Edwin I. Hatch Nuclear Plant  
Additional Information Related to the Staff's Review of the License  
Renewal Environmental Report (TAC Nos. MA8096 and MA8098)

**OFFICE OF NUCLEAR REACTOR REGULATION REQUEST FOR ADDITIONAL  
INFORMATION RELATED TO THE STAFF'S REVIEW OF THE ENVIRONMENTAL  
REPORT RELATED TO LICENSE RENEWAL FOR THE EDWIN I. HATCH  
NUCLEAR PLANT, UNITS 1 AND 2 (TAC NOS. MA8096 AND MA8098)**

FIGURE 2

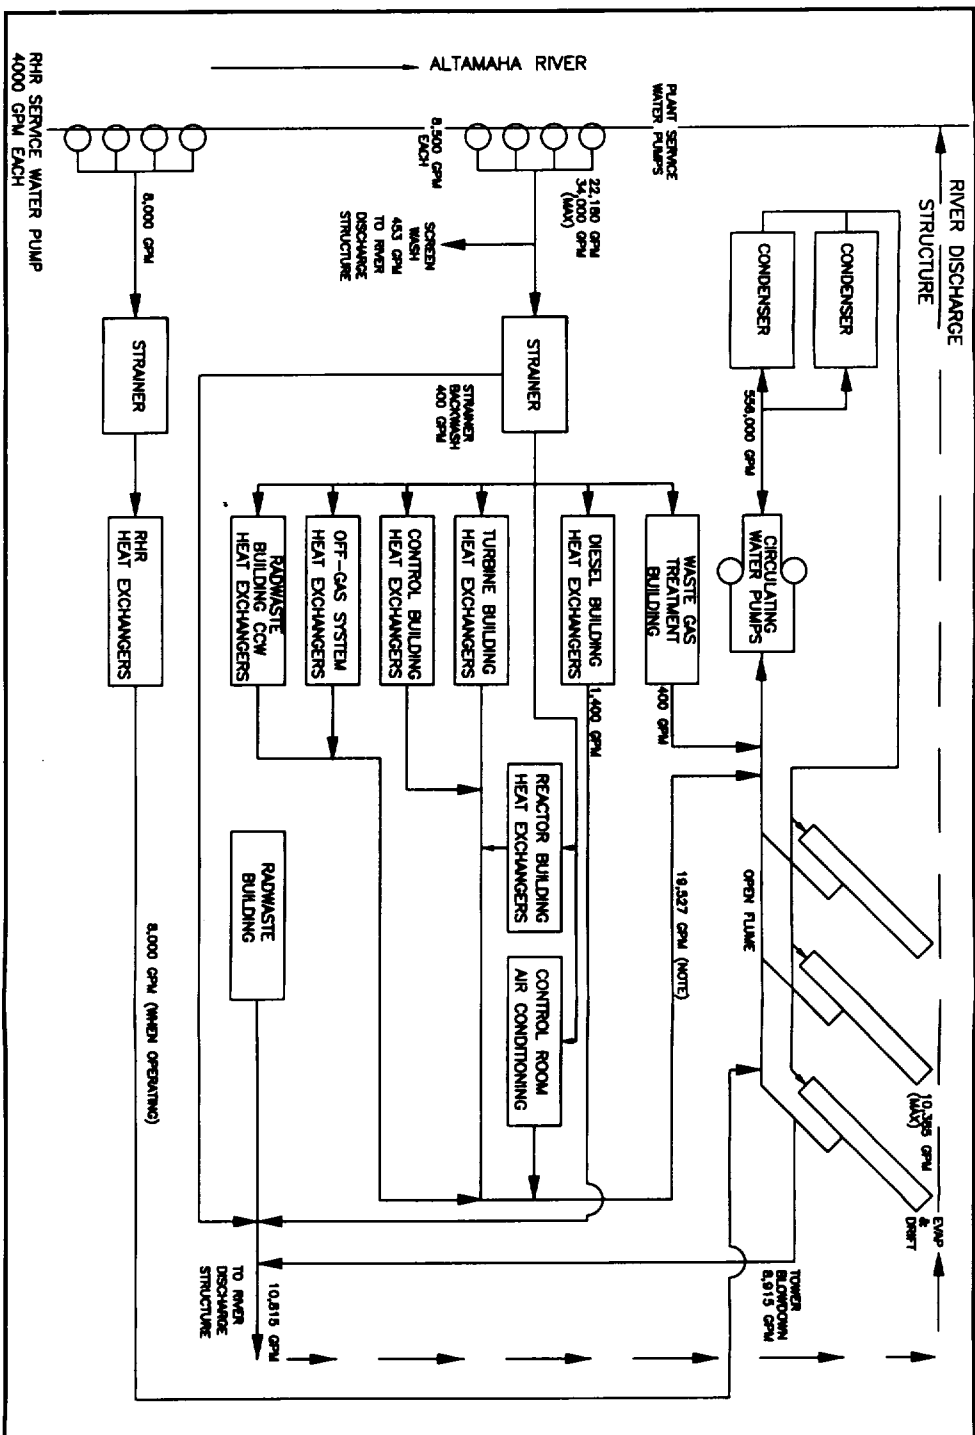
- 19. The values used in the water system flow schematic (page C-104 of ER) are outdated. Provide a plant water flow diagram with current flow values.**
1. The following revised Figure 2 (page C-104 of ER) reflects the current flow values. The flows are based on the normal mode of operation of the PSW system and are subject to variation depending on the number of components in service.

NOTE: FLOW LEVEL MAY BE CONTROLLED BY ADJUSTING THE TOWER BLOW DOWN AS PER PLANT PROCEDURE. ALSO, THE CIRCULATING WATER MAKEUP DEMAND IS LIKELY TO BE HIGHER THAN INDICATED BY THE DIAGRAM DUE TO THE USE OF ADDITIONAL 'HELPER' TOWER.
